UNITED STATES PATENT AND TRADEMARK OFFICE

10/539,761

Office Action Summary	Application No. 10/539,761	Applicant(s) ZIELKE, EBERHARD	
	Examiner GERARD T. HIGGINS	Art Unit 1794

FIG 1

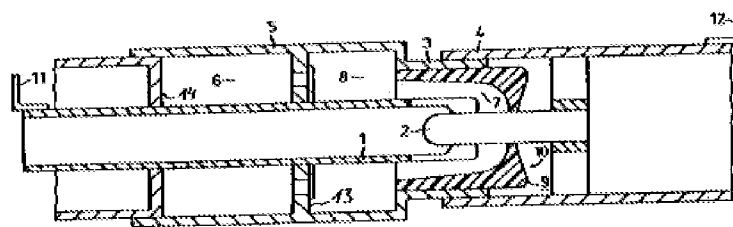
With regard to claim 1, 9, and 10, Zielke discloses an “insulating component, which is at least partially composed of plastic, for high-voltage systems, in particular for use in gas-insulated systems, whose conductivity is increased in the region of its surface,” which reads on applicants’ insulating material nozzle and the intended use of claims 1 and 9 that the electrical high-voltage device is a high voltage power breaker (col. 1, lines 9-12). Zielke further discloses parts **9** and **10** of Figure 1.

Part **9** is an “insulating component...which is normally composed of polytetrafluoroethylene,” which reads on applicants’ insulating material nozzle and applicants’ nozzle body (col. 3, lines 26-28). In order to prevent displacement currents and flashovers, the region of the end face **10** was treated with beta and gamma rays, “which leads to a reduction in the electrical resistance in the region which is subjected to irradiation” (col. 3, line 43 to col. 4, line 5). A reduction in the electrical resistance reads on applicants’ increased electrical conductivity. The end face region reads on

applicants' channel formed in said nozzle body, and it also reads on applicants' surface of said channel. The Examiner deems this to be the case because the end face region gradually funnels down to the constriction area for the arc contact piece **2**. It is therefore a channel towards that constriction area for the arc contact piece **2**.

Consistent with the above underlined portion of the MPEP citation, attention is drawn to Figure 1 of the specification of Patent No. 6,627,831 which discloses the shape of the endface region **10**. It is clear that the endface region may be made in the shape of a channel that funnels down to the constriction area for the arc contact piece **2**. Therefore, it would have been obvious to one of ordinary skill in the art to make the copending endface region a channel and for treating the surface of that channel to result in an article that renders obvious the article as presently claimed.

The Examiner has set forth a *prima facie* case that the resultant structure of the insulating material nozzle of Zielke anticipates or renders obvious applicants’ claimed invention. The Examiner deems this to be the case because the treatment with radiation occurs at the surface of the end face **10**, and therefore reads on said “mixture of first granules and second granules disposed on said surface and defining a portion of said channel” as claimed. The portions of the PTFE in the surface region of the end face **10** that are treated by the beta or gamma rays, i.e. change molecular structure, read on applicants’ first granules and first subvolumes, and the portions of the PTFE in
